Addendum No. 1

TO: Prospective Bidders
SUBJECT: Addendum No. 1
PROJECT NAME: Parking Lot Improvements
JJC PROJECT NO.: B23013

**JJC Main Campus Pavement
- Area 1
- Parking Lot S5**

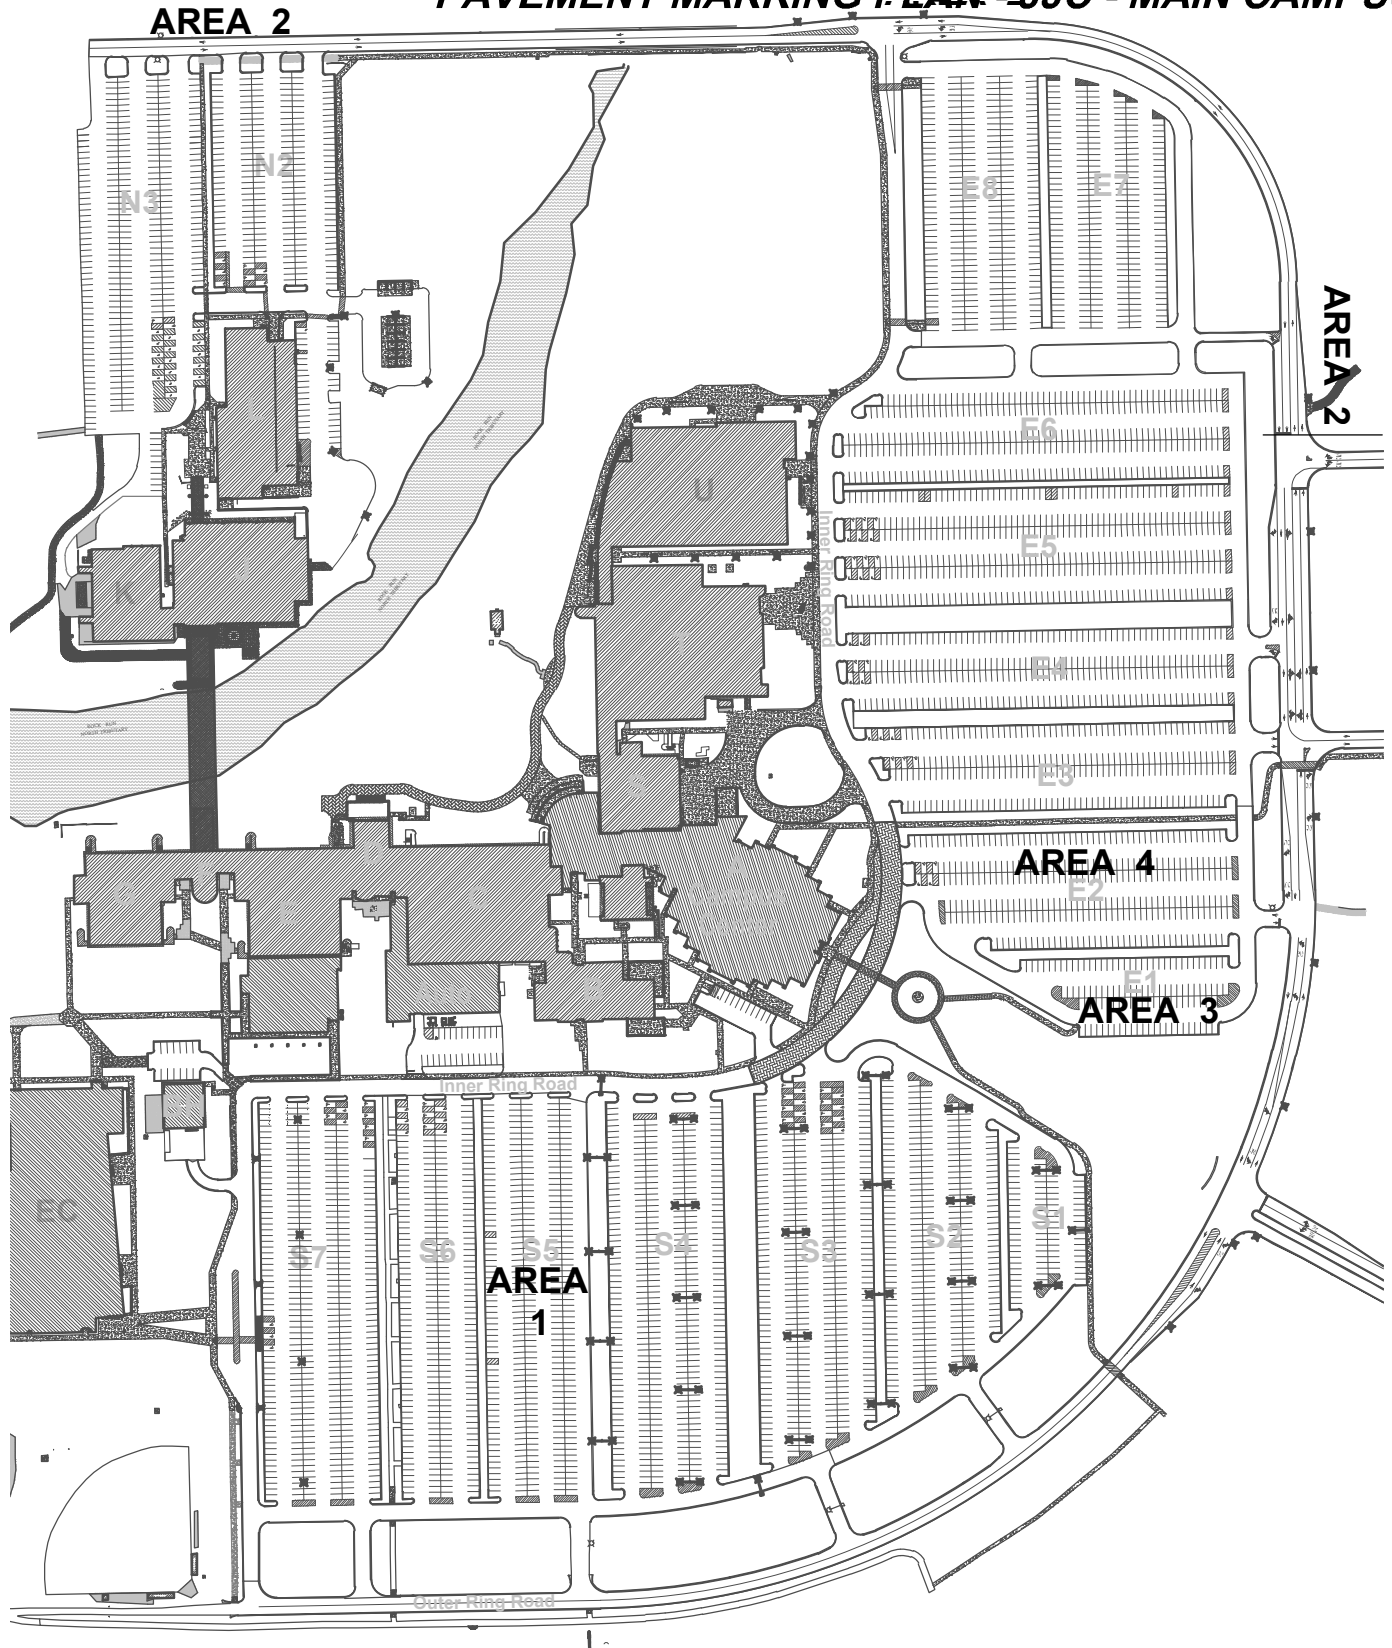
1. The plan depth of HMA resurfacing is not specified on the drawings. It was explained in the pre-bid meeting that lot S5 should be 2.0" (N50) and the ring road should be 1.5" (N70). Please clarify in the bid documents.

8. Please clarify the mill/resurface depth for Areas 1 and 2

17. I am looking to clarify the scope of the work required in the different areas for the 2023 Parking Lot project you have out to bid. At the pre-bid it was discussed that an N50 Surface would be required in Area 1 and that an N70 Surface would be required for Area 2. Since that is not listed anywhere on the drawings or specs, I am just looking to confirm that is the expected scope of all bidders.

Response: The information has been added to the drawings. It is also noted in the scope of work for the project. Parking lot S5 is 2.0" remove and replace with N50 and the outer ring road is 1.5" remove and replace with N70.

Response: The information has been added to the drawings. It is also noted in the scope of work for the project. Parking lot S5 is 2.0" remove and replace with N50 and the outer ring road is 1.5" remove and replace with N70.

Response: The information has been added to the drawings. It is also noted in the scope of work for the project. Parking lot S5 is 2.0" remove and replace with N50 and the outer ring road is 1.5" remove and replace with N70.

JJC Main Campus Pavement - Area 2 - Outer Ring Road North

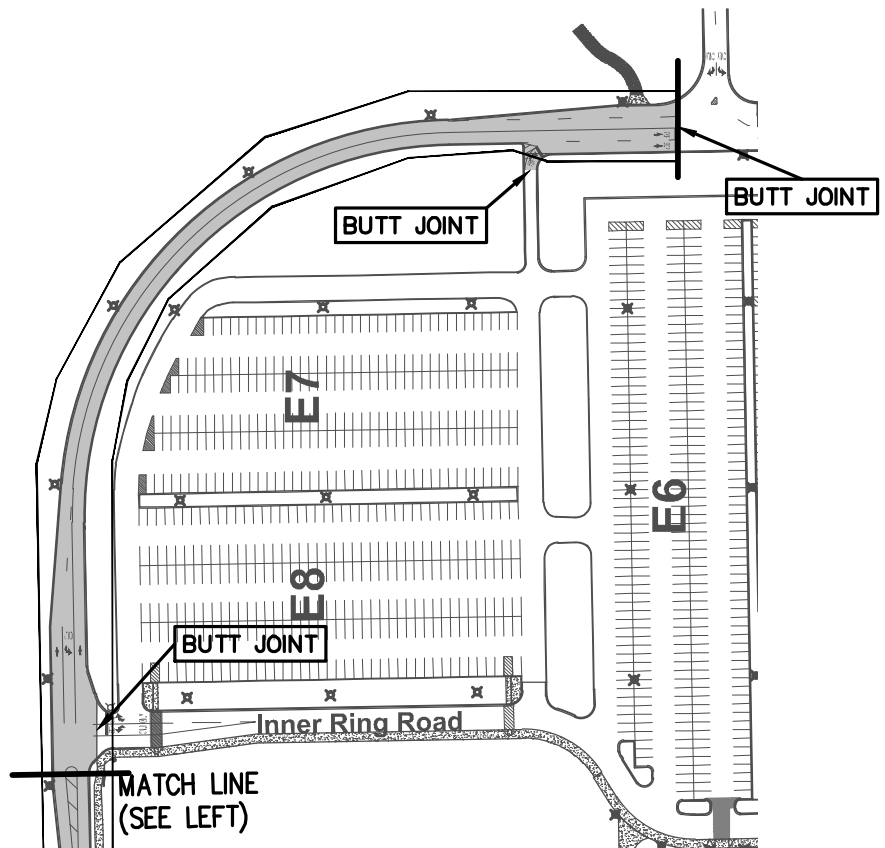
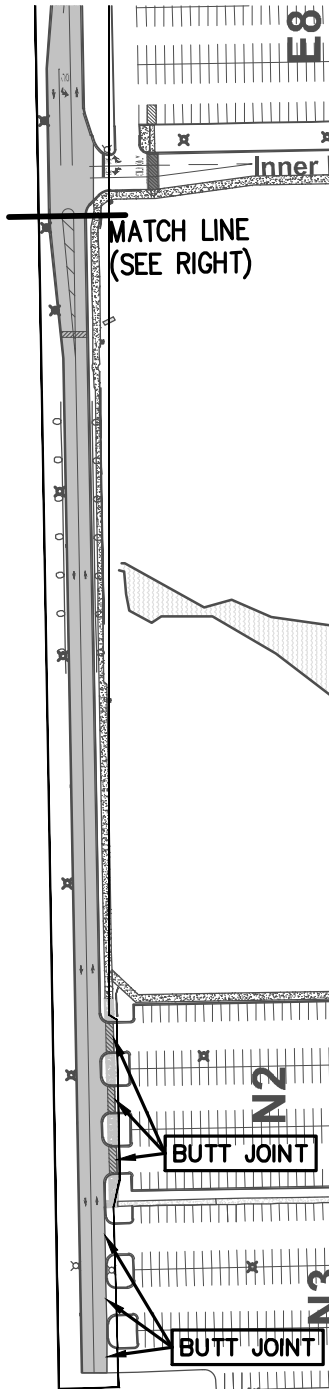
9. There is a note mentioning N70 Asphalt being used on the drive lane, can N50 Asphalt be used on the entirety of the project?

Response: No.

**JJC Main Campus Pavement
- Areas 3
- Parking Lot E1**

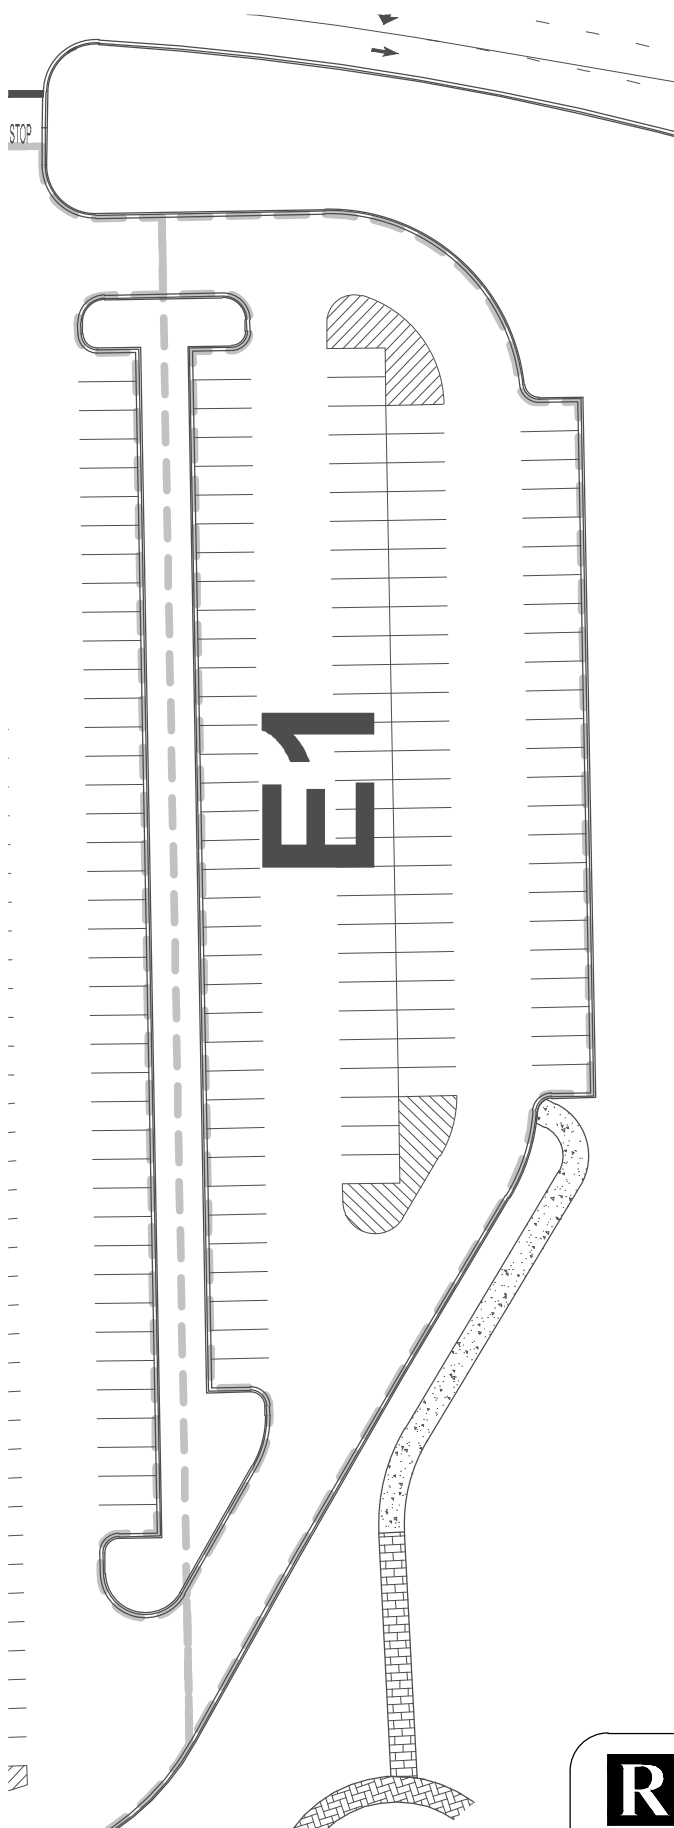
2. Crack sealing is not specified for lots E1 and E2 on the drawings, but was discussed at the pre-bid meeting. Please clarify areas that will require crack sealing. Please also specify any work requirements beyond what is included in the specifications.

7. Please clarify the proposed asphalt scope of work for Areas 3 and 4 – are they mill/resurface areas or full-depth asphalt replacement? If full-depth replacement is required, please clarify the cross-section.

18. Also mentioned was the scope of work in Areas 3 and 4. The drawings don't indicate what is to be done other than restriping, but the pre-bid conference discussed that crack routing and sealing was to be done in those areas. Please clarify that this is the expected scope of work in those areas.

Response: The information has been added to the drawings. It is also noted in the scope of work for the project. Parking Lots E1 and E2 improvements will include crack filling and seal coating. All crack of 1/8" and greater shall be routed and filled.

Response: The information has been added to the drawings. It is also noted in the scope of work for the project. Parking Lots E1 and E2 improvements will include crack filling and seal coating. All crack of 1/8" and greater shall be routed and filled.

Response: The information has been added to the drawings. It is also noted in the scope of work for the project. Parking Lots E1 and E2 improvements will include crack filling and seal coating. All crack of 1/8" and greater shall be routed and filled

AREA 1
PARKING LOT S5
FULL DEPTH PATCH
NOT TO SCALE

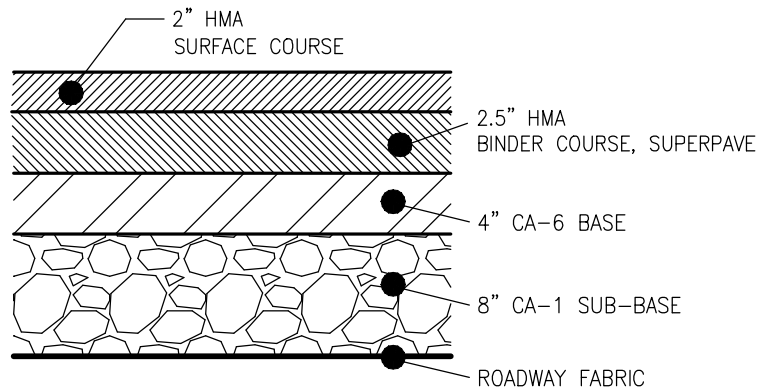
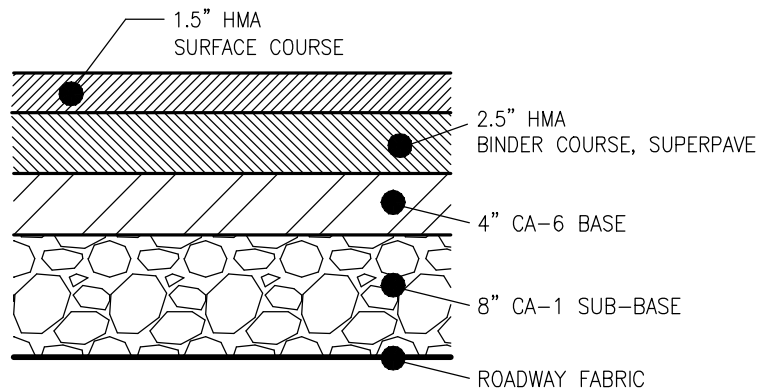
5. Please clarify the required depth and desired quantity of any HMA base patching to be included in the base bid.

Response: A pavement patching detail has been added to the plans. The bid should include 100 SY.
